"STRATHAM NH SPCA"

Plan Name:	COVER SHEET
Project:	NH SPCA EXPANSION, STRATHAM, NH 102, 104, & 108 PORTSMOUTH AVENUE
Owner of Record:	NH SPCA, LISA DENNISON, DIRECTOR 104 PORTSMOUTH AVENUE, STRATHAM, NH 03885

**RE: Site Plan Application for NH SPCA Expansion
104 Portsmouth Avenue, Stratham, NH
Map 13, Lots 83, 84 & 85
JBE Project No. 17088**

C3

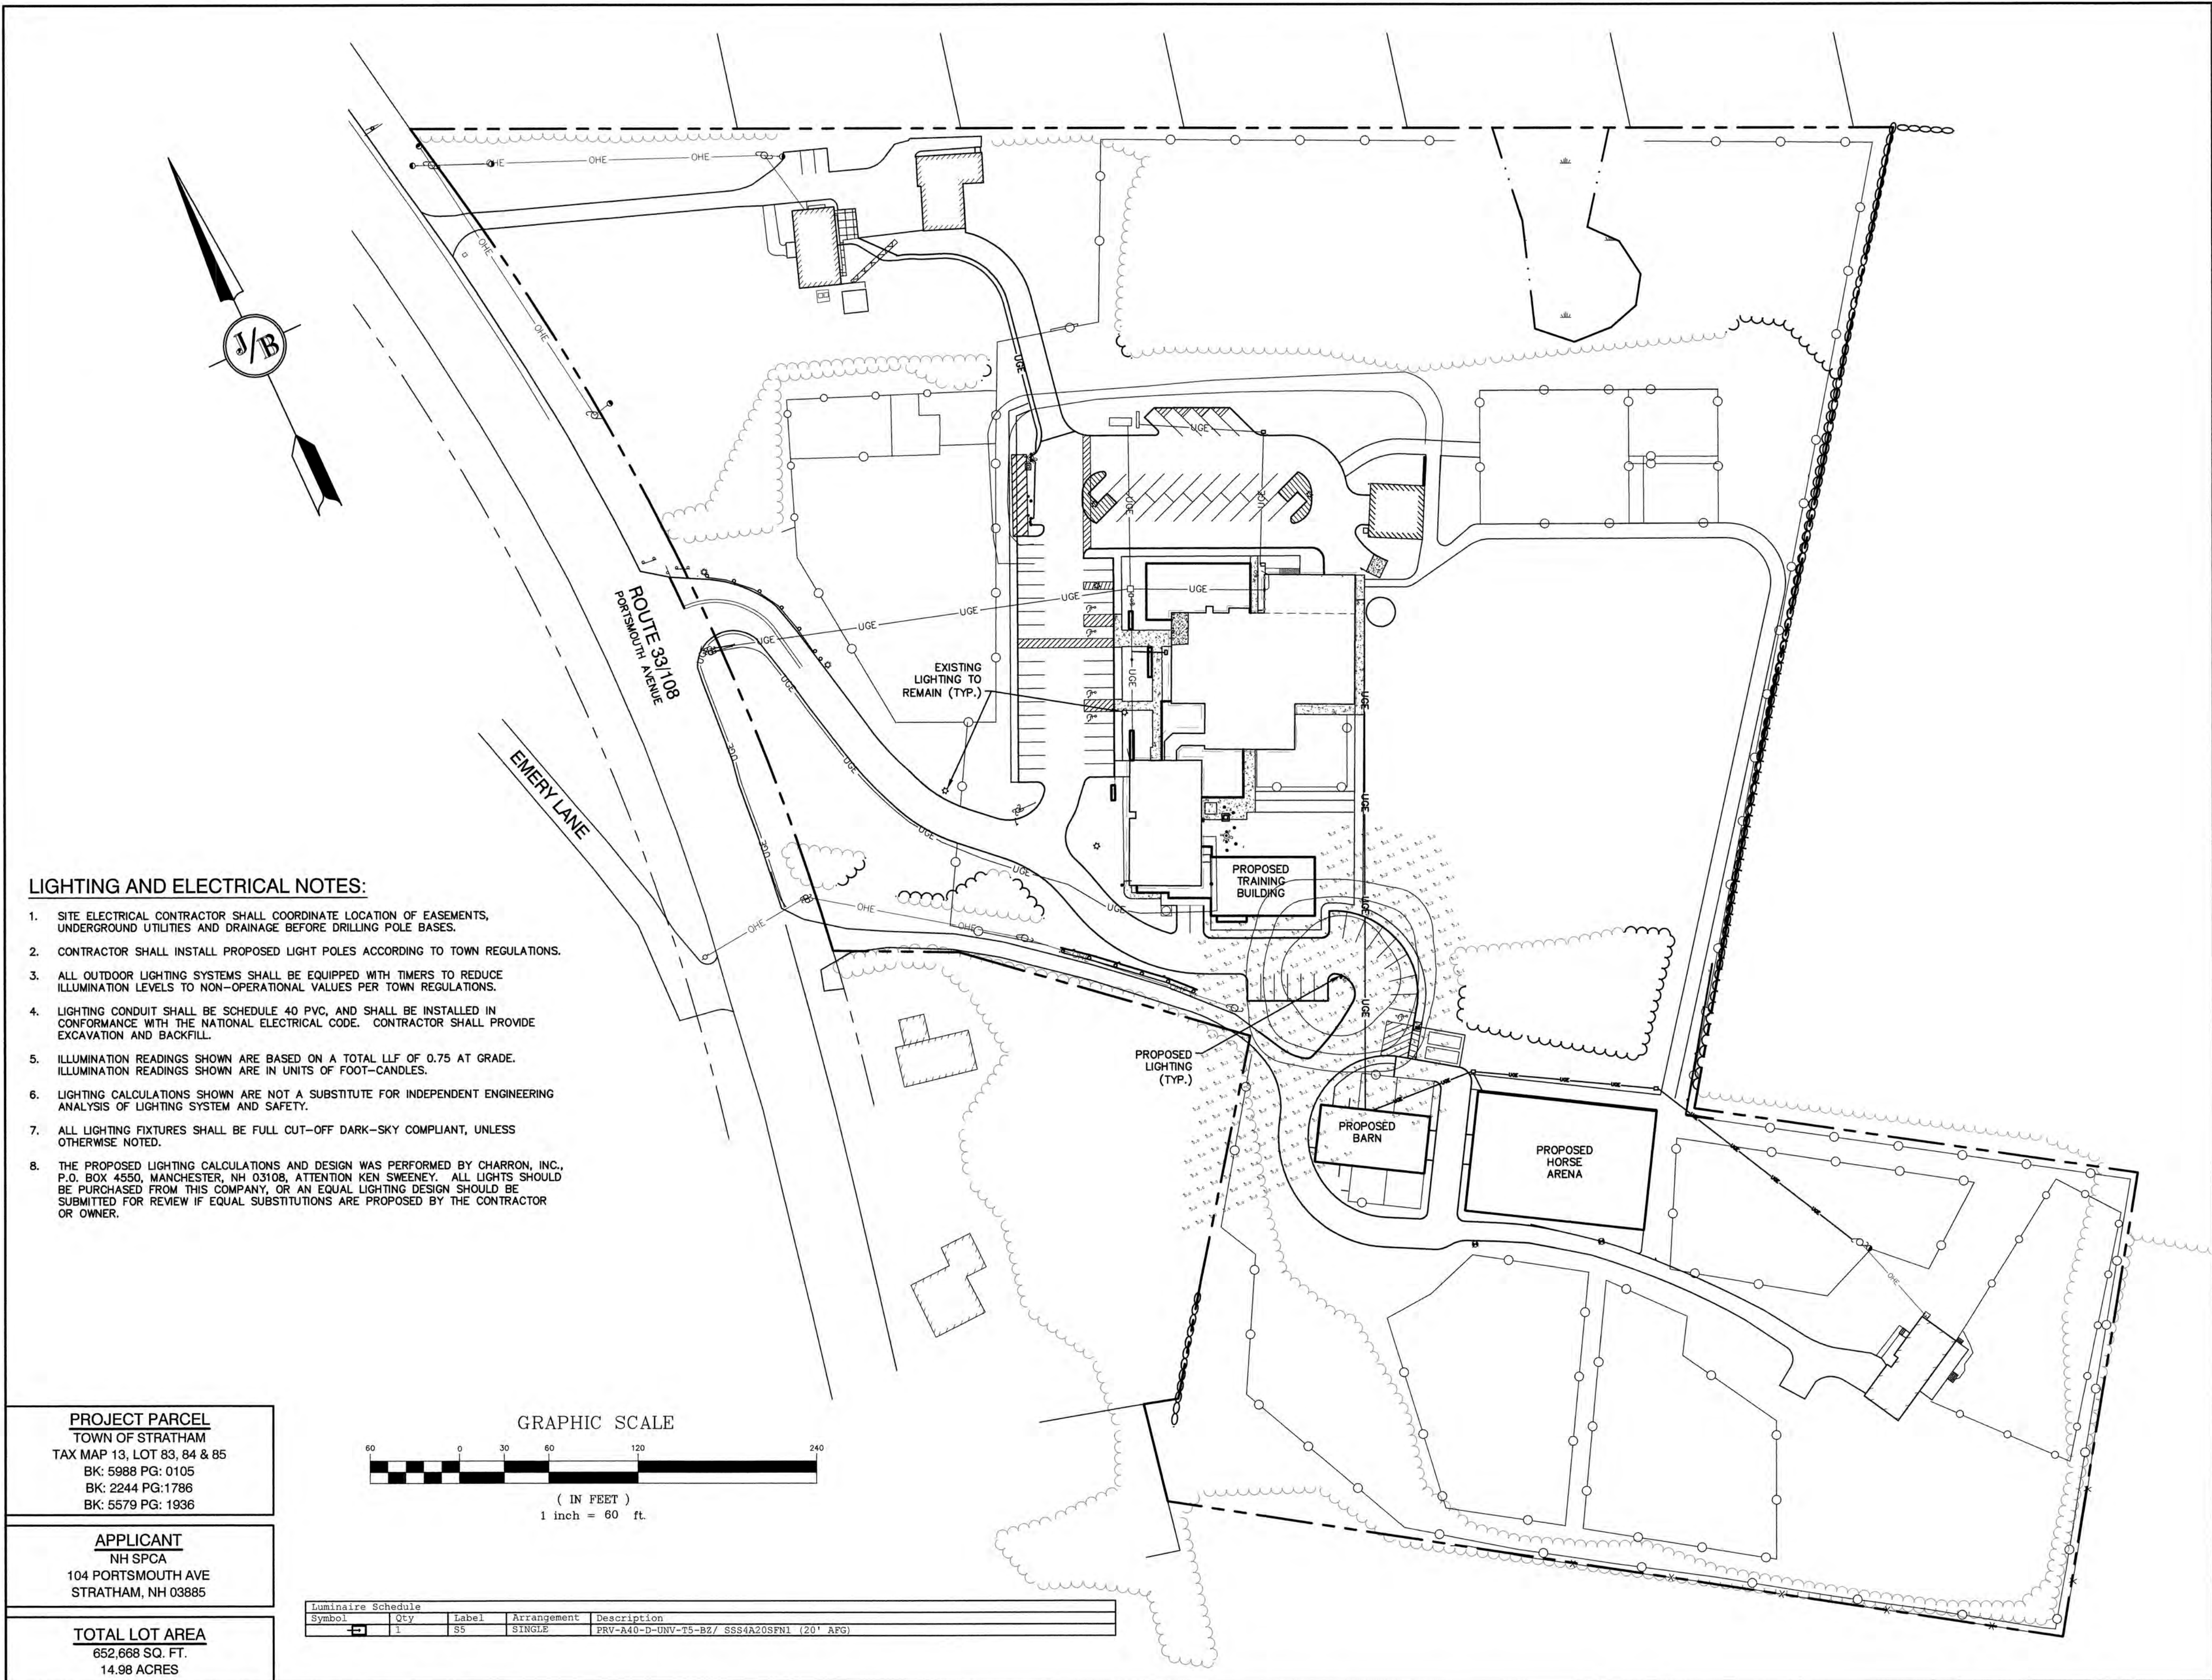
4. *July 15, 2019: According to the NH Stormwater Manual, the minimum setbacks from a water supply well to a stormwater discharge is 75 feet. If Pond 14P is designed to infiltrate, it would be in violation of this condition. HW recommends that the Applicant review the well setbacks and design of Pond 14P.*

New Comment: It appears that the Applicant has revised the footprint of Pond 14P to extend into the 75 foot well setback again. HW recommends that the Applicant revise the footprint to avoid the setback zone.

August 28, 2019: The Applicant has changed to design such that raingarden 14P is outside of the 75 foot well setback. The Applicant has addressed this comment.

SEAL & SIGNATURE:  DATE:
PROJ. NO: 1814
DWG BY:
CK BY:
DWG NO:
L101
FILE No:

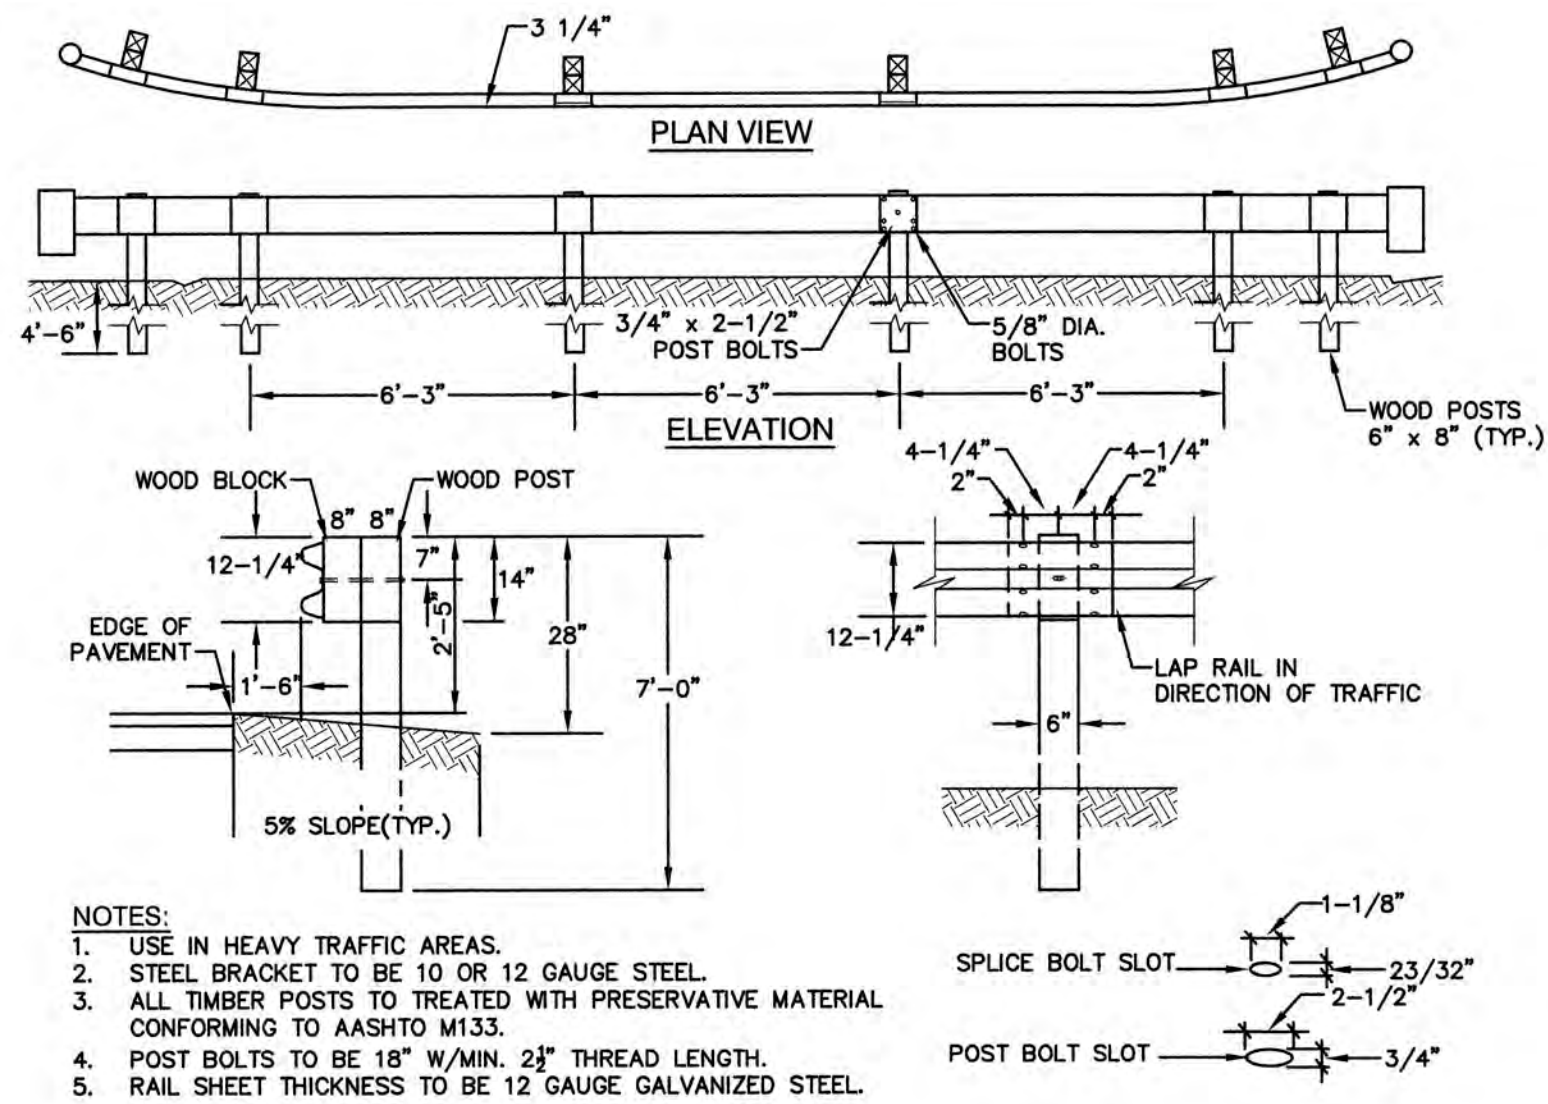
The Applicant states that all proposed raingarden are included on the Grading and Drainage Plan (Sheet C3) and that the Landscaping Plan has been provided. The Landscaping Plan provided only includes planting details for proposed raingarden 14P and does not include details for raingardens 18P, 12P, and 13P. HW recommends that the Applicant provide landscaping details for the additional rain gardens, as the details show on sheet D2, refer to the landscaping plan for plantings.

NEW RESPONSE: The updated Landscape Plan Sheet L101 is delivered herewith.
